DATE: March 20, 2019

AGENDA ITEM #4

**TO:** Design Review Commission  
**FROM:** Calandra Lewis, Assistant Planner  
**SUBJECT:** 18-SC-34 – 1555 Kensington Circle

Exhibit 1 – Existing Site Plan with Tree Protection Fencing Markup

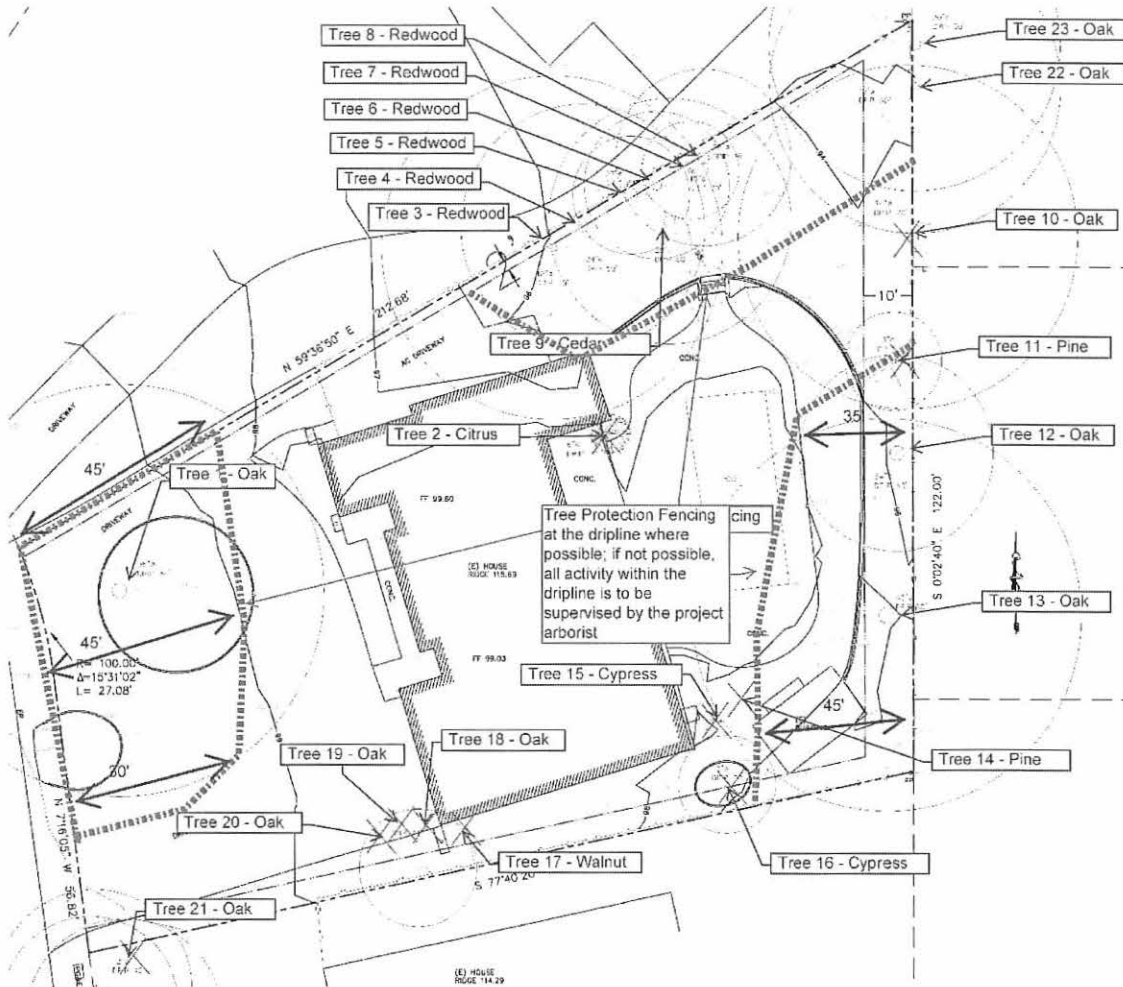
1. Site Plan + Project Data:
  - b. B: Since the proposed footprint of the new house is within the dripline of the existing Oak tree in the front yard as well as other adjacent trees on the property, please submit an arborist report that provides an evaluation of the trees' health and condition. The report should analyze the potential impact of proposed construction of the new house and basement/layback area on the trees and provide necessary protection and mitigation measures (including construction methods and pruning thresholds). The report should assess onsite trees and significant trees on adjacent properties with driplines over the subject property. The report should prioritize avoidance measures over mitigation measures.

- ii. The report should provide a sketch of the existing tree driplines which should be translated to the other plans and prescribe a tree protection zone for placement of the protective fencing.

An initial arborist report was prepared on October 16, 2019 as a tree inventory and assessment. I have reviewed the proposed site plan, elevation plans, grading and drainage plan, and landscape plans in relation to the avoidance/protection measures or recommendations. I have included the existing site plan with tree protection fencing locations depicted (Exhibit 1) which should be translated to the other plans. I have also included the initial assessment spreadsheet that includes an evaluation of the trees' health (Exhibit 2).
